PROJECT
RYLANDS BUILDING,
MANCHESTER

TITLE
COMPARISON ELEVATION C NORTH
- NON MATERIAL AMMENDMENT

DWG No
AL[05]2264

ISSUE FOR
PLANNING DOCUMENT

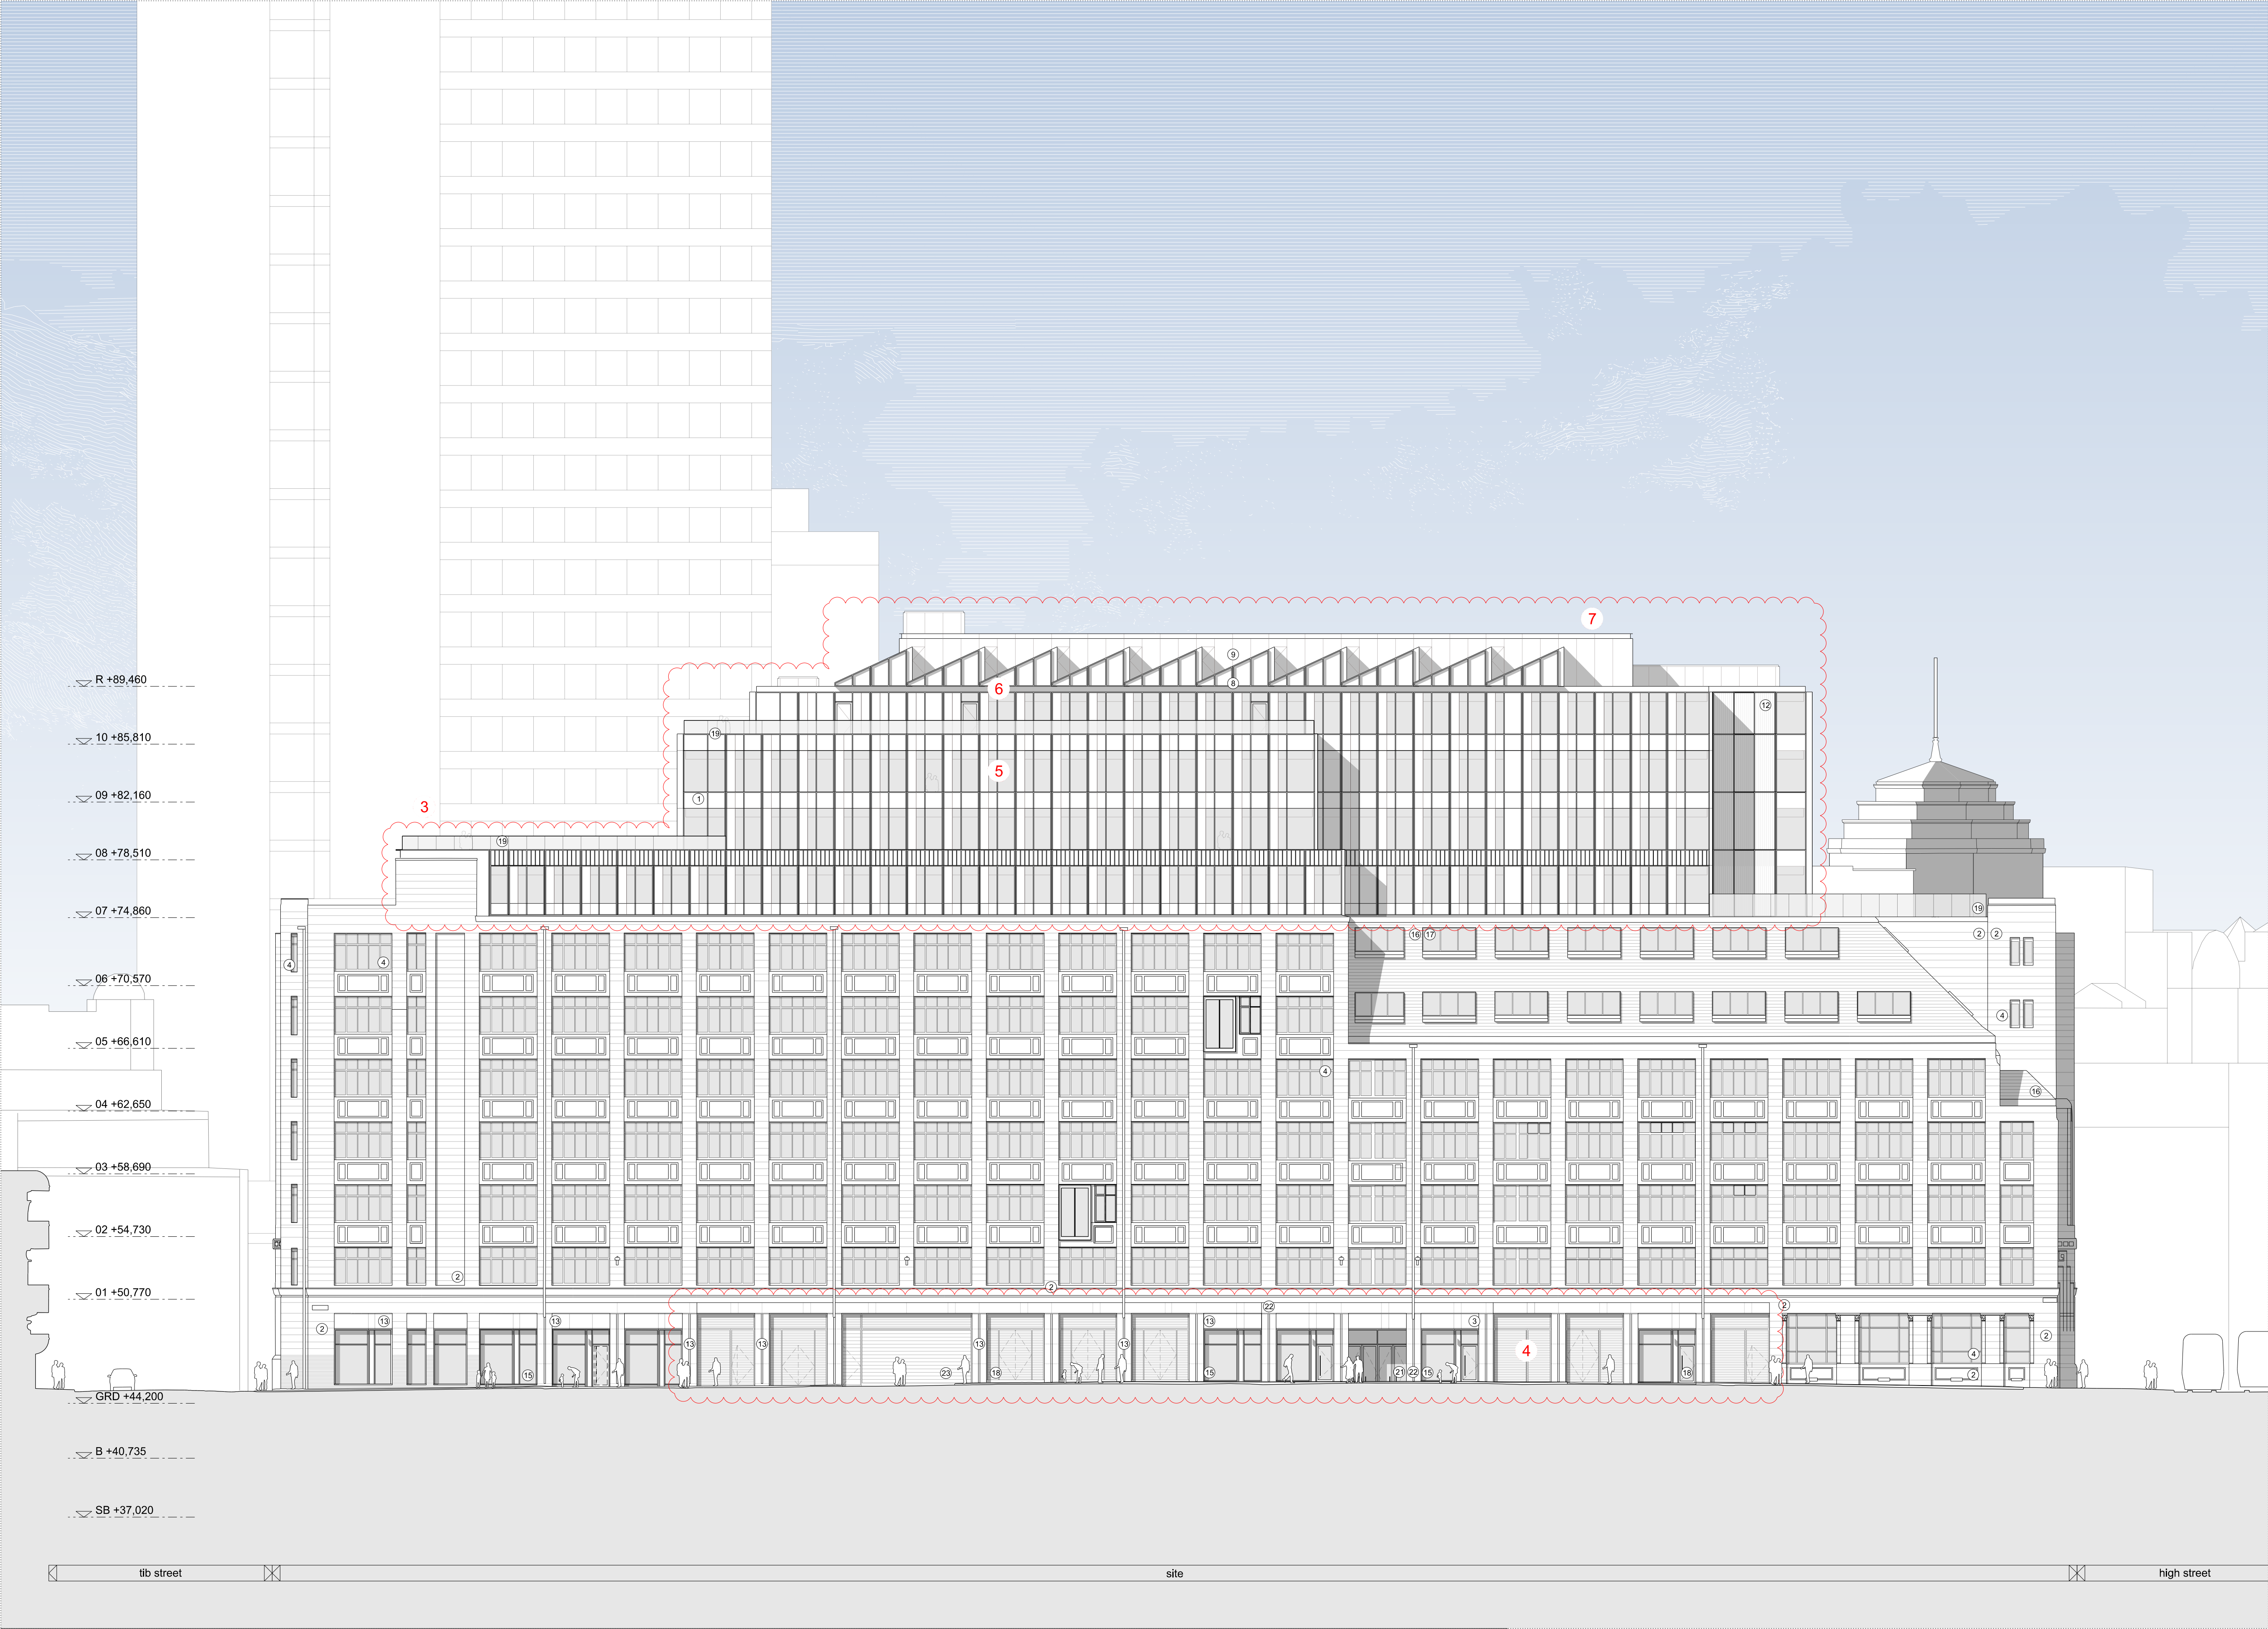
PRINCIPLE DESIGN DEVELOPMENT				
1. Creation of a south facing terrace to respond to change in plan form below and mitigate increase in building height.	3. Amended form of south east level 07 elevation to respond to change in plan form.	5. Rationalisation of the extension facade to improve buildability and building thermal performance.	7. Overall height of the development, and massing to High Street and Bridgewater Place, remains unchanged from the consented scheme.	9. Leisure Unit 01 entrance relocated to address Market Street.

2. Extension massing responding to reduced atrium width below, aligning with existing building grid to reduce structural intervention and increase lettable area.	4. Updates to cycle entrance, loading bay, substation, arcade entrance, and retail unit frontages (as noted on general arrangement plans).	6. Minor variation in external terrace and eaves heights to facilitate buildability of the new build extension.	8. Dedicated office entrance created to stair 3 addressing Tib Street.
